ADDENDUM NO. 6
TO GENERAL, MECHANICAL AND ELECTRICAL
ABERDEEN PUBLIC WORKS
MAINTENANCE BUILDING
ABERDEEN, SOUTH DAKOTA

Addendum Dated: March 27, 2026

Original Plans and Specifications Dated: February 20, 2026

1 WALL SECTION @ OIL ROOM
3/16" = 1'-0"

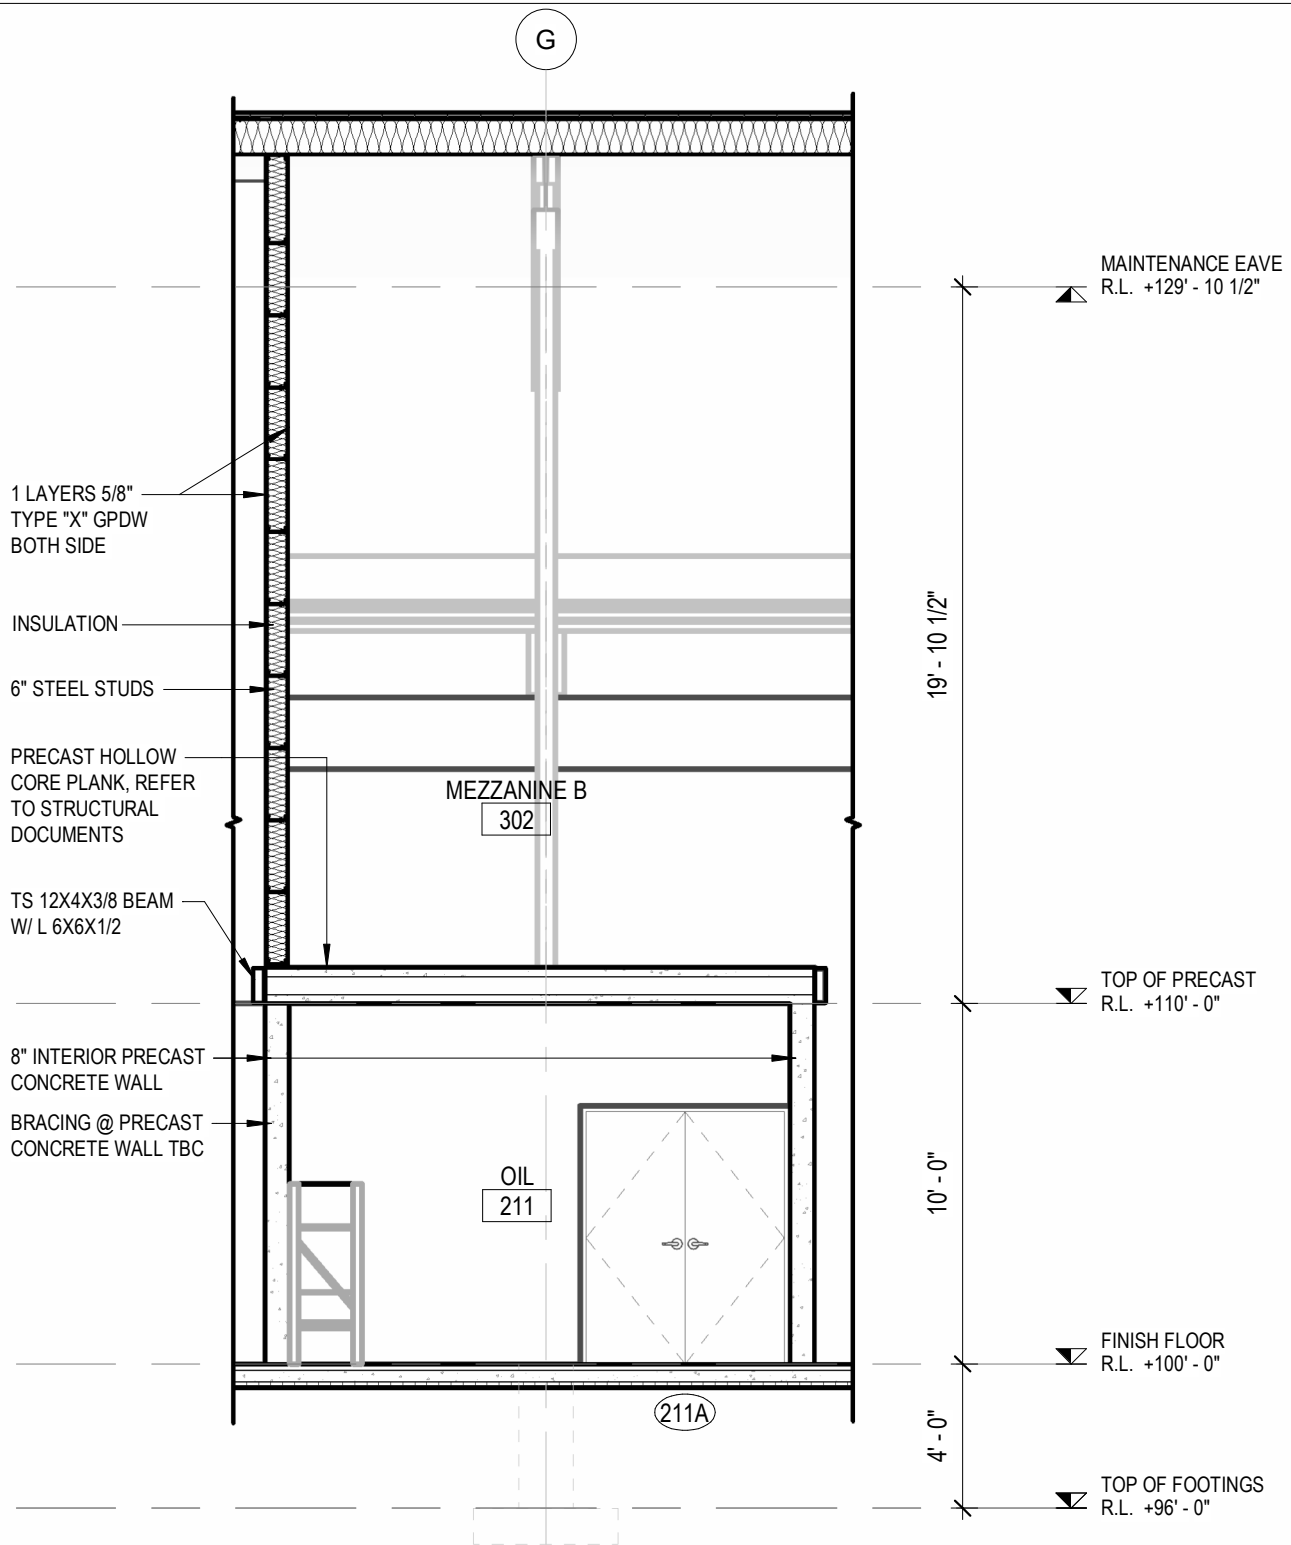
7. For clarification on Oil 211 wall construction, see attached details 1/2 and 1/3.
8. For clarifying information on the mezzanine railing and gates, see attached details 1/4, 2/4, 1/5, 2/5, & 3/5. The Washbay catwalk railing is to follow the same design requirements shown in the attached details.

1 SECTION 1
3/64" = 1'-0"

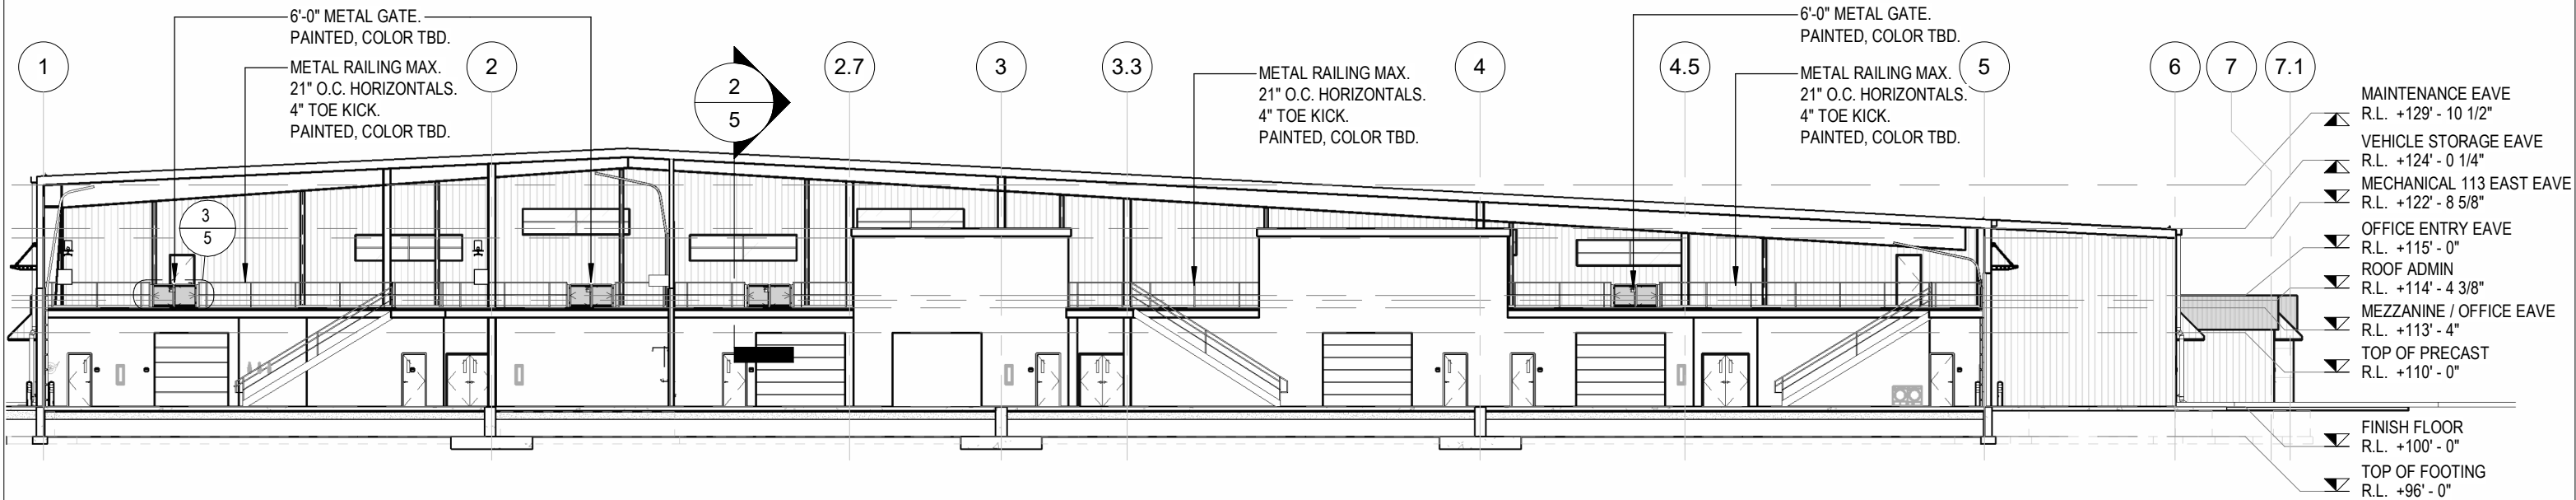
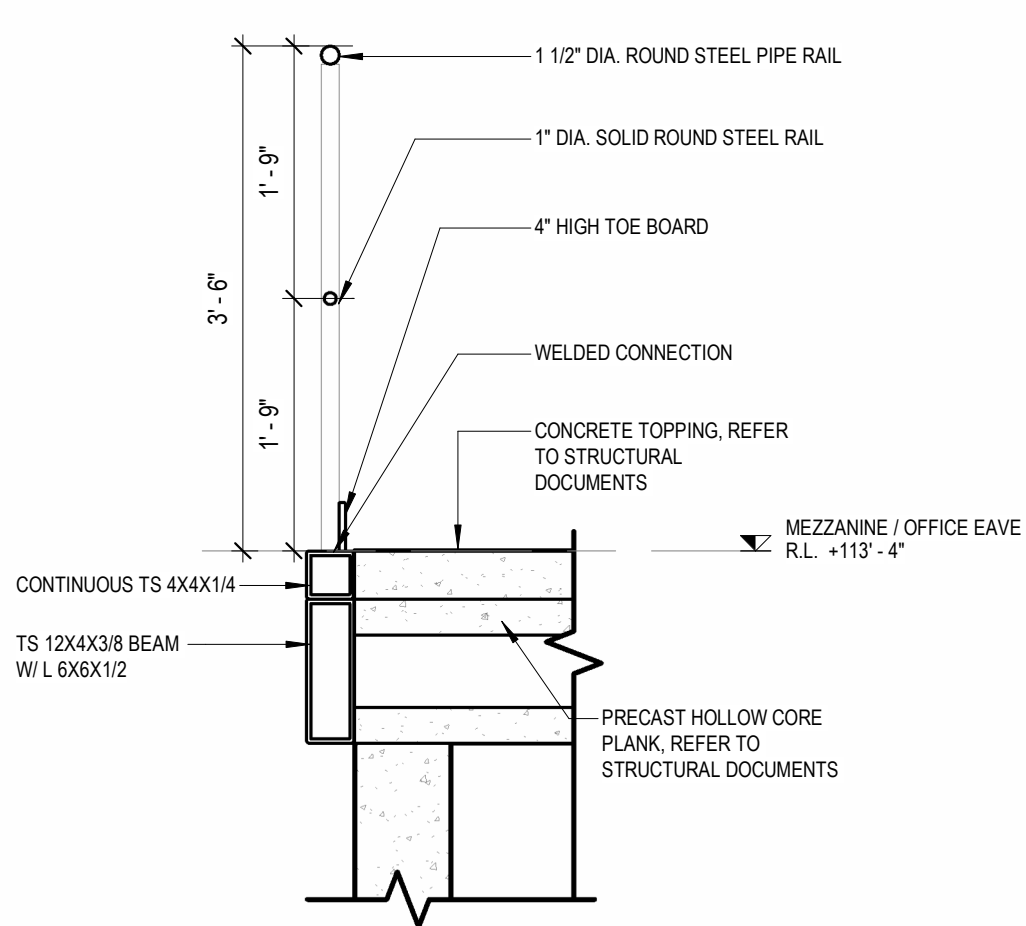
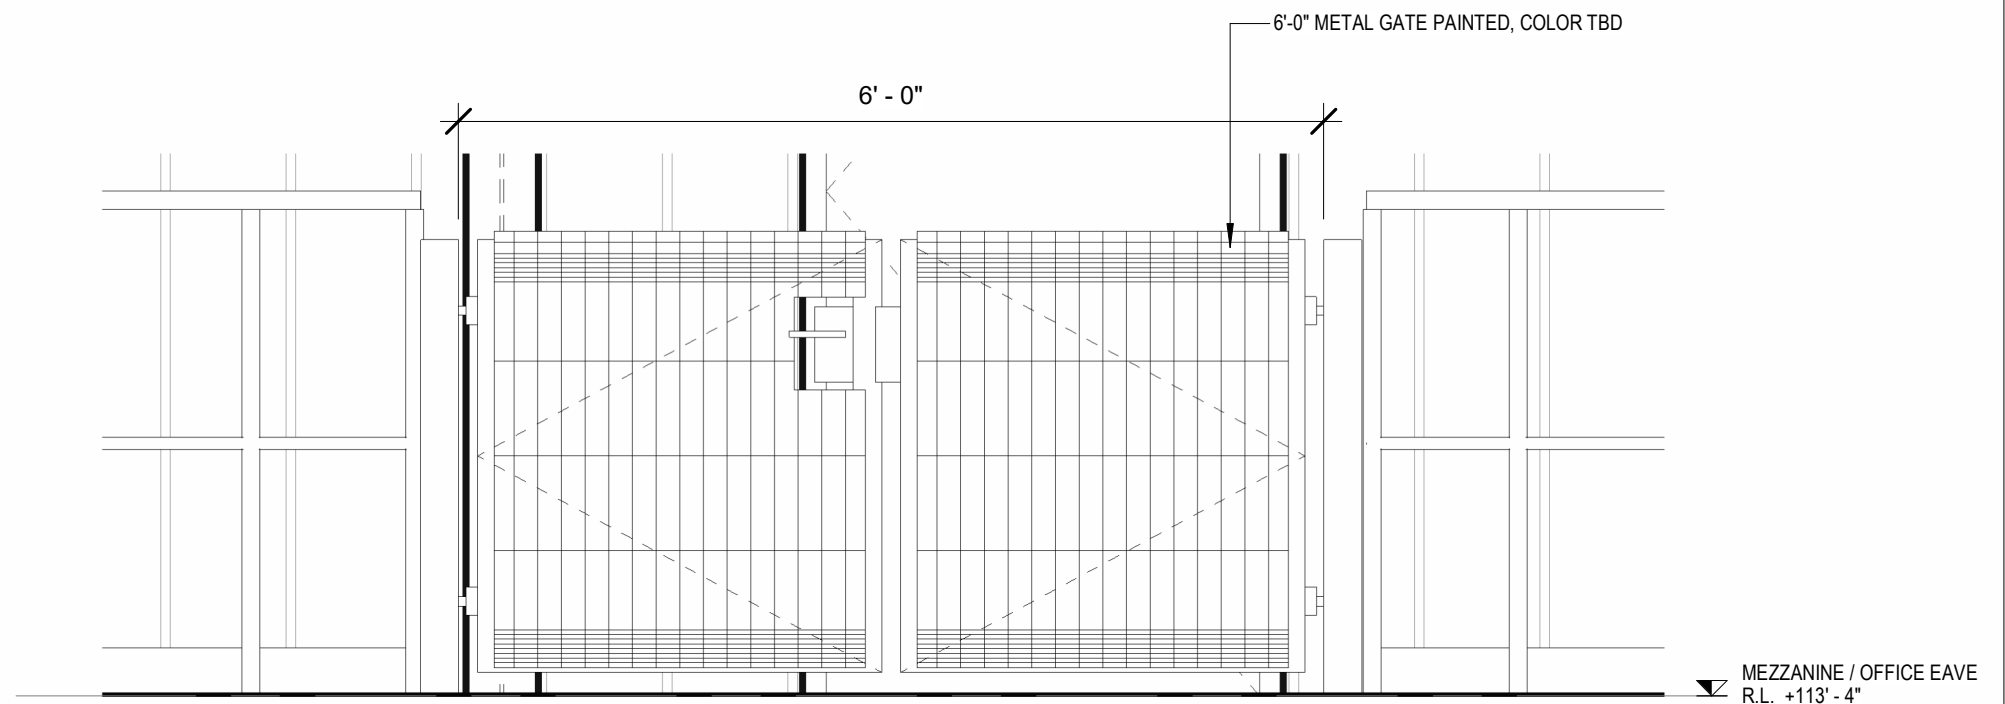
- a) Details 1/A3, 2/A3, & 3/A3:
 - I) Delete notes "REMOVABLE GATES" and replace notes with "OPEN GATES". See attached details 1/4, 2/4, 1/5, 2/5, & 3/5 for updated mezzanine railing and gate information.
 - II) Wall Containing door 301C, delete "2HR FIRE PARTITION" and replace with "1HR FIRE BARRIER". See attached details 1/4, 2/4, and Wall Type 4B.

① Training Room Operable Wall
3/16" = 1'-0"

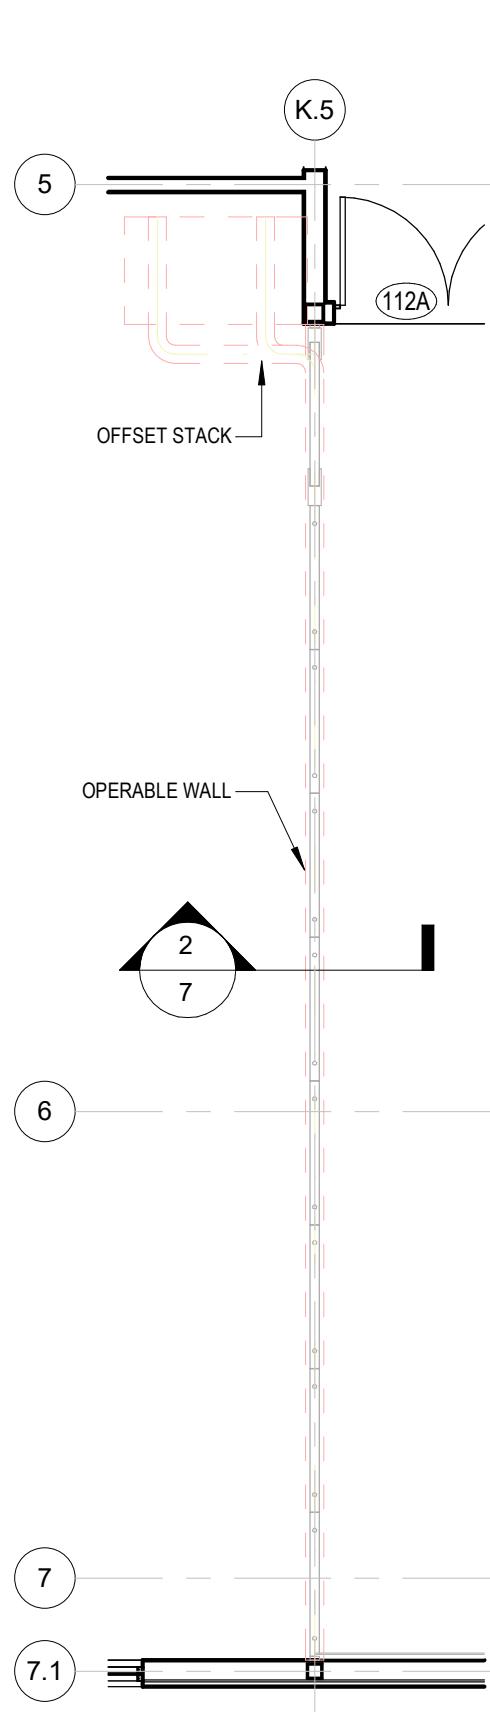
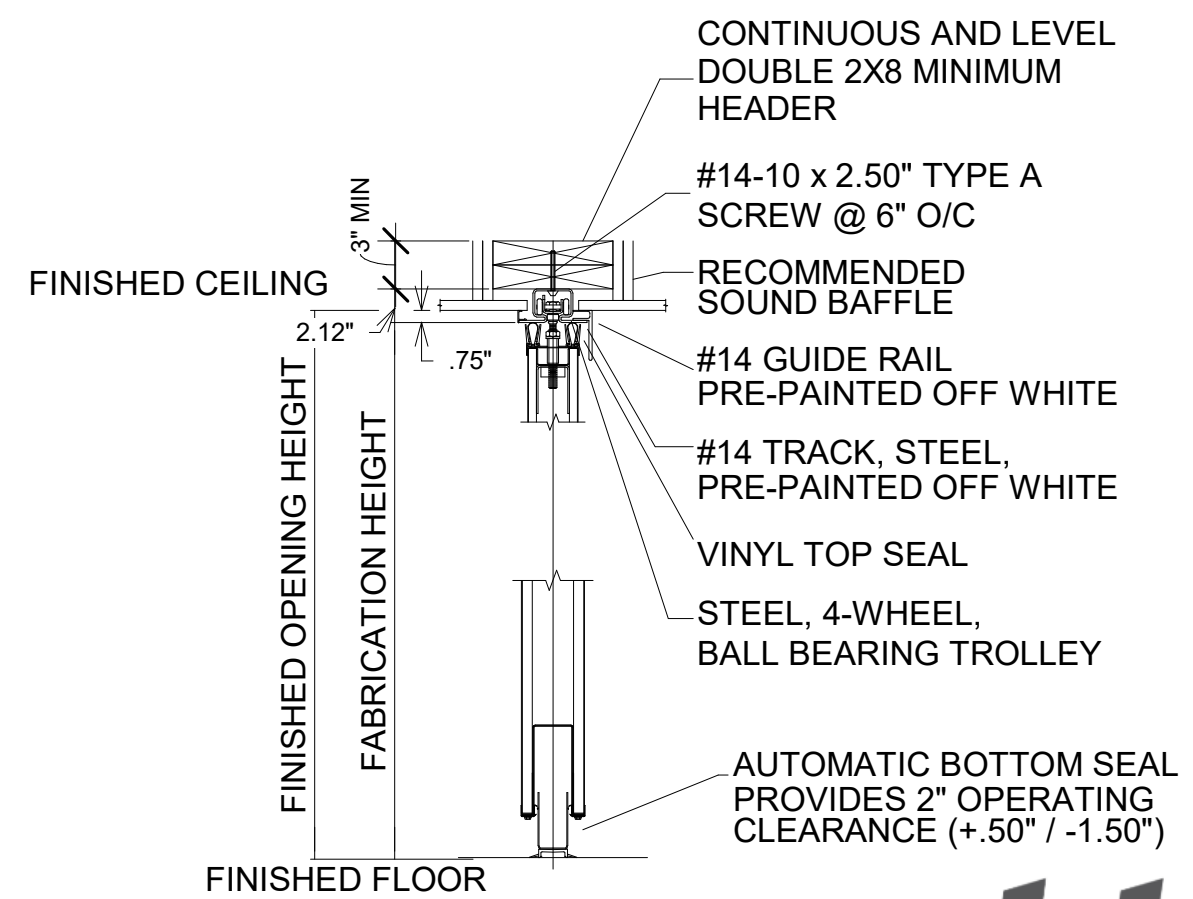
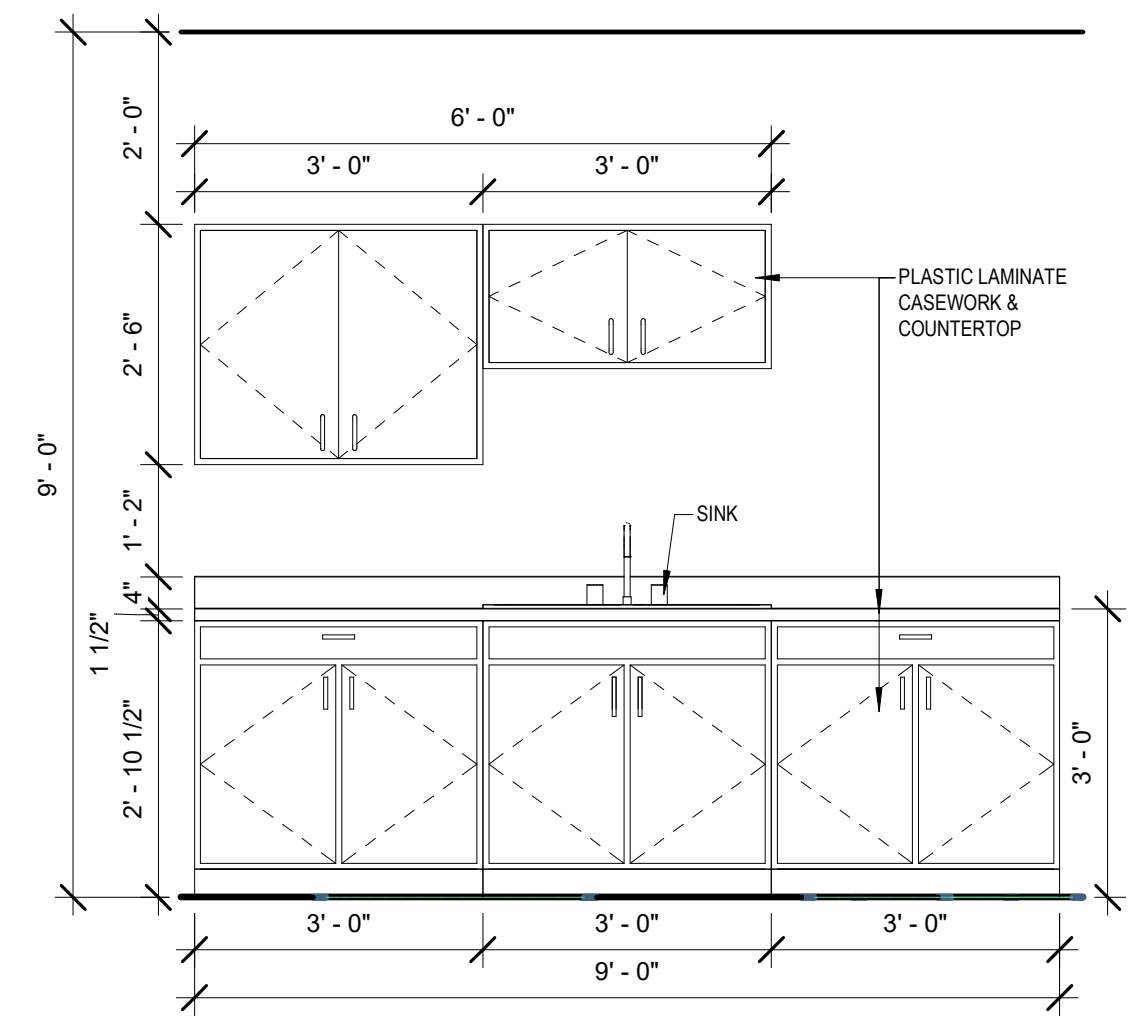
9. Add the attached detail 1/6. Floors are to be sloped to floor drains as shown.
10. See attached details 1/7, 2/7, & 4/7 for clarification on the operable wall.

11. See attached elevation, 3/7, for casework depicted in Street HQ Conference 119, Traffic HQ Conference 120, Pump Conference 125, Pipe & Meter Conference 126, Mech. HQ 127, & Solid Waste Conference Room 131, on sheets A6, A6-A, A6-B, & A35.

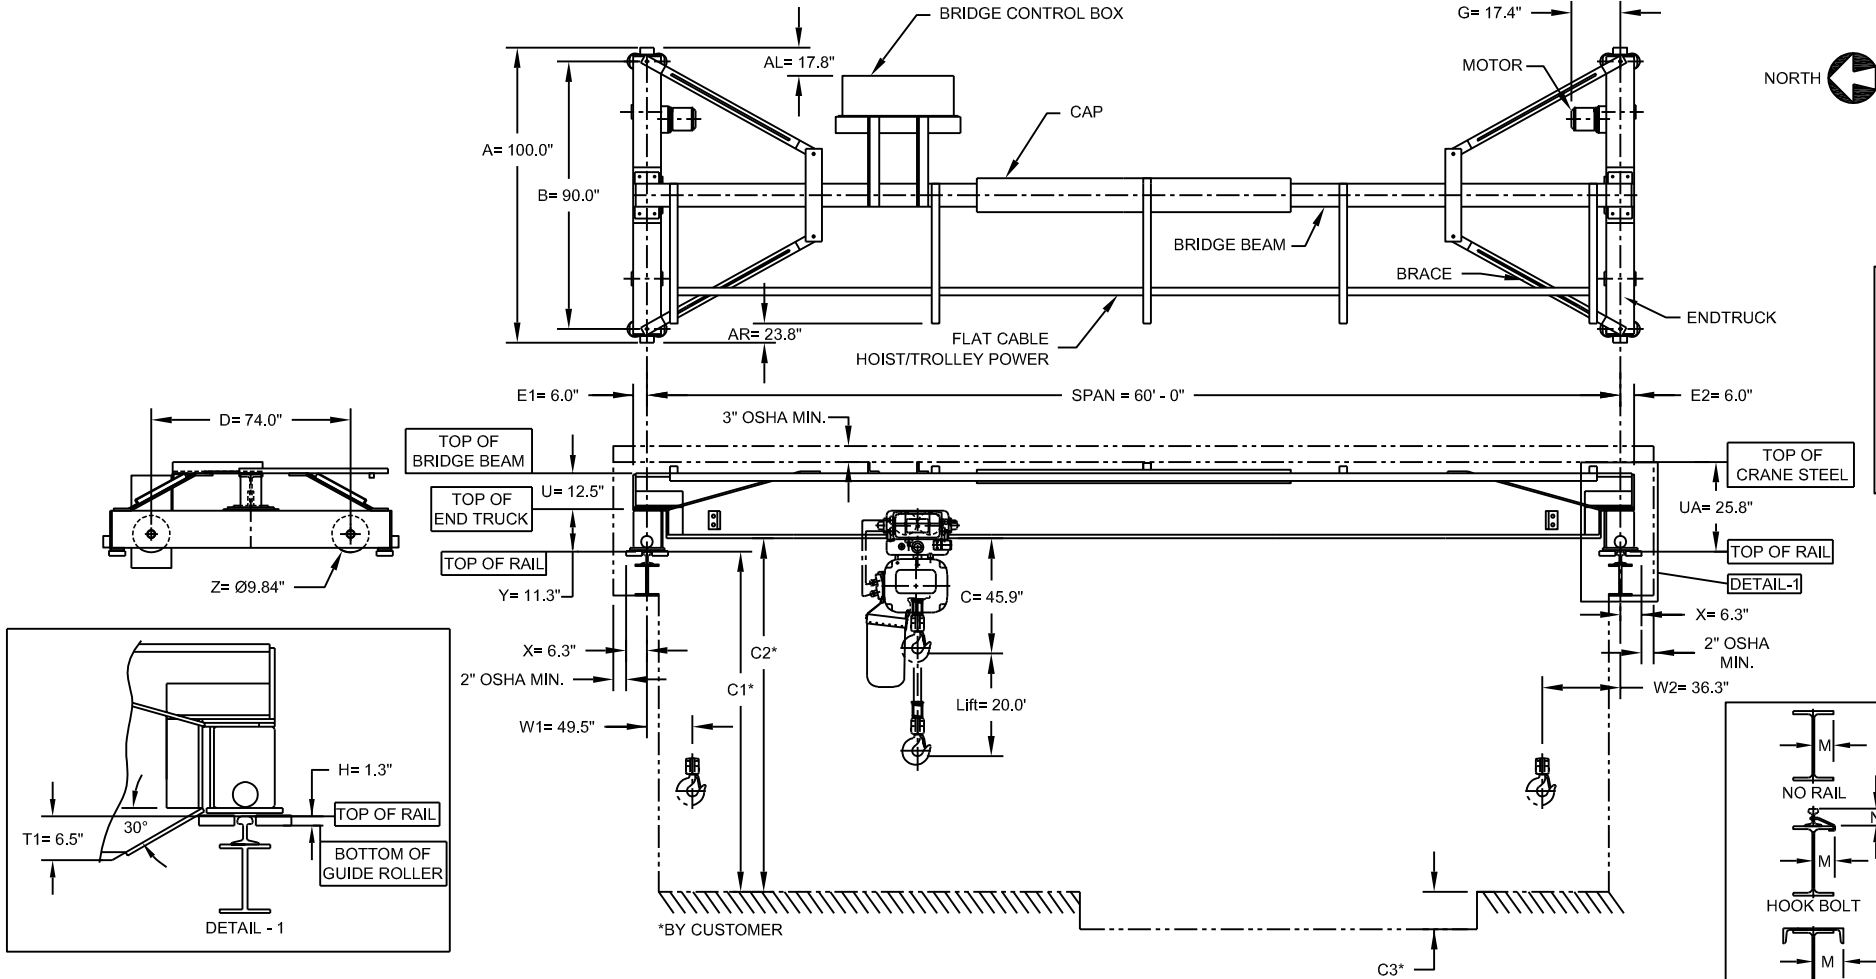
- 8. Section 21 22 13 – Bridge Cranes
 - a) Service 210 – 7.5 Ton Bridge Crane
 - b) Welding 212 – 2.5 Ton Bridge Crane
 - c) Pump 203 – 1 Ton Gorbelt Bridge Crane (See attached crane detail 42130).
